Three Mile Island Nuclear Station, Unit 1 (TMI-1)  
Operating License No. DPR-50  
Docket No. 50-289

Three Mile Island Nuclear Station  
Unit 1  
Reactor Containment Building  
Ring Girder Surveillance

Ref: USNRC Letter May 3, 1977  
Request for Additional Information

*SKETCH #1*

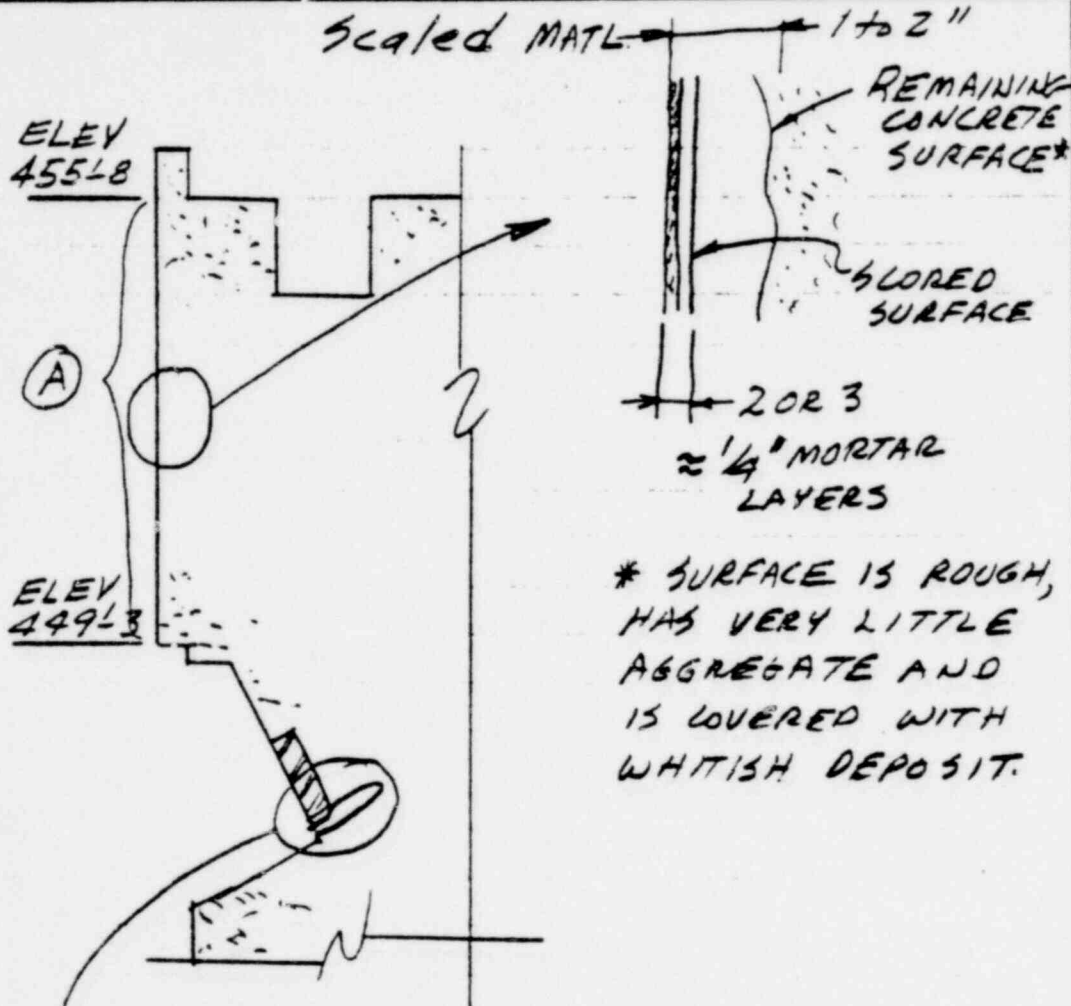
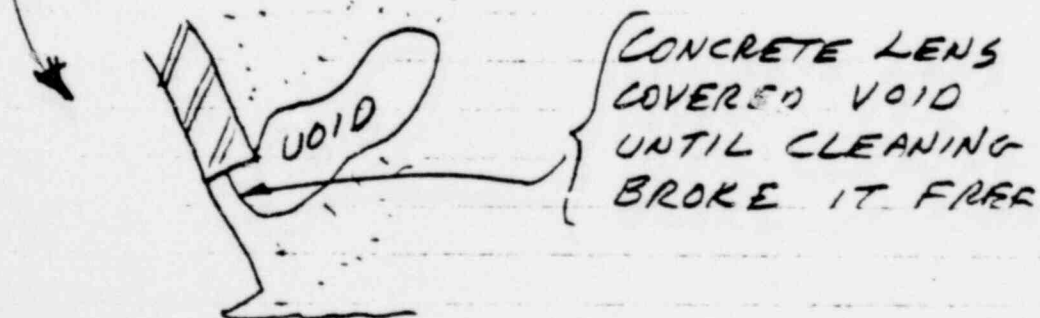
1. Figure 3 of the referenced report shows areas where the ring girder "facing" has broken away. Describe the function of the "facing". It is not clear whether it is part of the structural concrete or a fascia. If the "facing" is not structural, provide assurance that eventual cracks can be uncovered during visual inspection. If the "facing" is structural address the effect of the spalling on the structural integrity of the ring girder. Indicate the depth and area of the broken away "facing".

3. Figures 6 thru 12 present sketches of seven voids which were found around the dome tendon bearing plates.
  - a. Explain why these voids were not discovered during previous inspections.

- b) Outline the procedure by which the effect of the voids on the structural integrity has been evaluated. Address the fact that the voids will act as stress raisers and therefore may generate future cracks. Discuss environmental factors that may facilitate local damage. In light of these concerns, address the effects on the original factor of safety of the design. Discuss in detail the approach used to predict losses in tendon force.

The "facing" is a surface patch on the outside vertical face of the upper area of the Reactor Containment Building Ring Girder.

There is evidence of surface cracking and/or breaking away of "facing" (scaling) in the region designated as A in Sketch #1 around the entire circumference of the ring girder. The scaling is more prevalent around the North half of the structure than the South half. An examination of the scaled material indicates that two to four layers of finishing mortar has been applied in the area.

A visual inspection of a substantial region of the ring girder surface has been conducted using the nomenclature of ACI Committee 201 Report "Guide for making a Condition Survey of Concrete in Service". The surface cracking of the vertical surface can be described as pattern cracking and does not extend beyond the patching material. The condition of the surface which was exposed by breaking away of material can be described as one of severe scaling with encrustations.

With regard to the function of the "facing", the construction drawings of this area and the FSAR indicate a minimum cover of 2" for reinforcement. The scaling may have reduced the actual cover to less than specified. However, exposed reinforcing bars or rust stains which could be attributed to reinforcement corrosion in either the scaled or cracked areas has not been observed. Any significant corrosion of the reinforcement would be accompanied by increased scaling and discoloration which would be easily detectable. A review of the design calculations indicates that the vertical and circumferential reinforcing near the surface of the affected region is not required for satisfactory structural performance. It serves as minimum reinforcement for shrinkage and temperature.

In any event the surface condition around the ring girder circumference does not reduce the margin of safety for any design basis load combination. The condition is a problem of appearance rather than structural adequacy.

It has been surmised that the voids were covered by lens of concrete (see Sketch #1) which resulted in their being undetected during previous inspections. The use of a reciprocating power wire brush (needle gun) to clean off the surface of bearing plates prior to painting apparently

SKETCH # 2

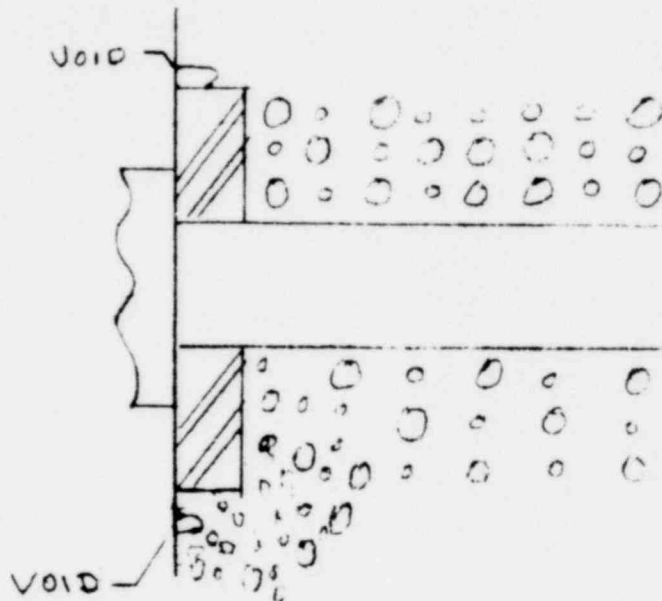
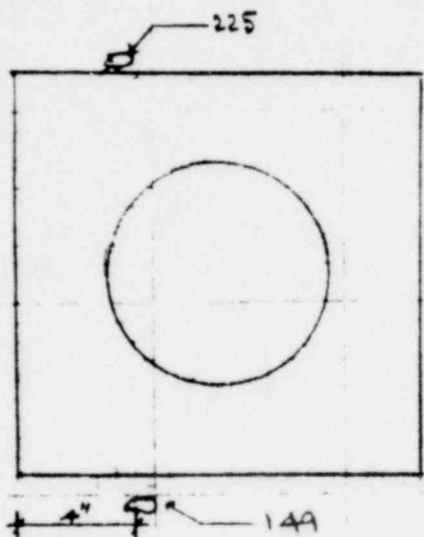
2. In Table 4, Note 4, it is indicated that small cavities were found in the vicinity of tendon bearing plates 149 and 225. Describe these cavities. Indicate their location with respect to the tendon in a sketch. Present a discussion of their effect on the margin of safety and present a suggested method of repair.

The reported cavities are approximately 1" in diameter, 1" deep and located as illustrated in Sketch #2. They represent an acceptable as-built condition since they do not extend into the bearing area and do not degrade the structural integrity of the containment. Therefore, corrective measures are not required. However, they should be treated in the same manner as the other voids.
